Technical Bulletin #172

# Cable Modifications per x710 & x810 MDS Radios

Totalflow Technical Bulletin  
Version 1.0 Revision AB (08-23-2010)

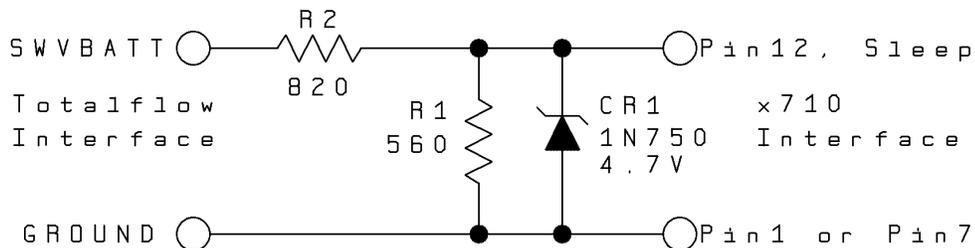
The following Totalflow cables have been obsoleted and replaced with:

**2015026-005** replaced with 2103990-001

**2015026-010** replaced with 2103990-002

**2015026-004** replaced with 2103990-003 (This cable is a spare part only. It is no longer offered in Comm Kits.)

These obsoleted cables are still good cables to use with the MDS X310 Series. **However, the newer replacement cables will ONLY support the MDS x710 and x810 Series.**

The updated cables incorporate a voltage divider (two resistors) and a 4.7V zener diode to prevent voltages in excess of 5V on pin 12 of the MDS radio.
